PCN – Process Change Notification

Change:	G30.B and MA140 series
Date:	2016/05/25
Author	Haley Tsai

Illustration of Change (G30.B & MA140 series)

**New drawing
(Add step inside the bottom housing)**

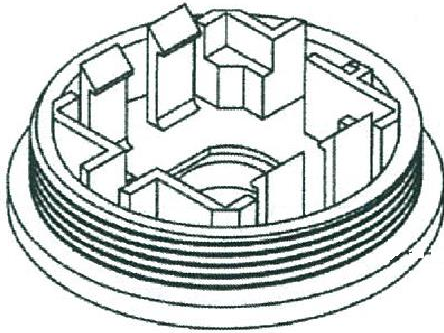
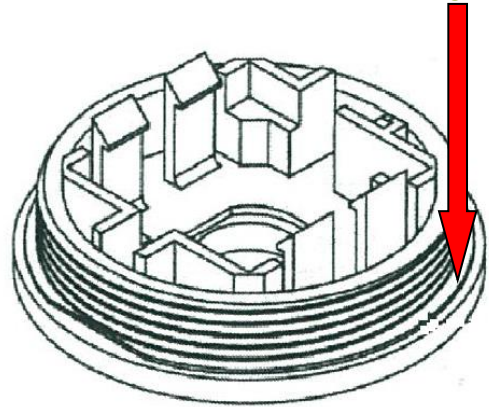
1. A step was added inside the bottom housing to ensure a tighter assembly.
2. Extended the screw thread on the new design of the bottom housing to make the assembled product more stable.
3. Added a fixing screw at the bottom of the housing to make antenna more stable.

Old drawing

**New drawing
(Add screw thread)**

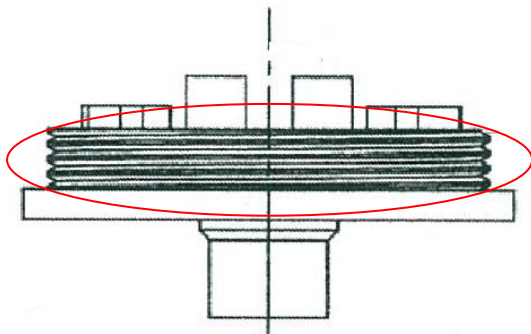
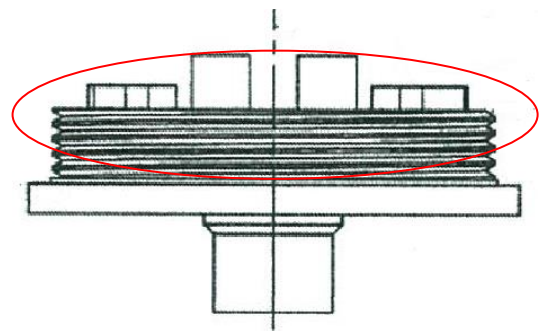
Old drawing

**New drawing
(Add fixing screw)**

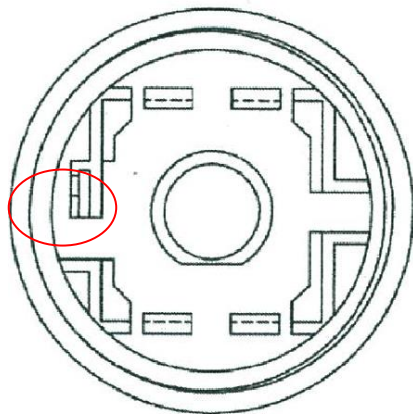
Old drawing
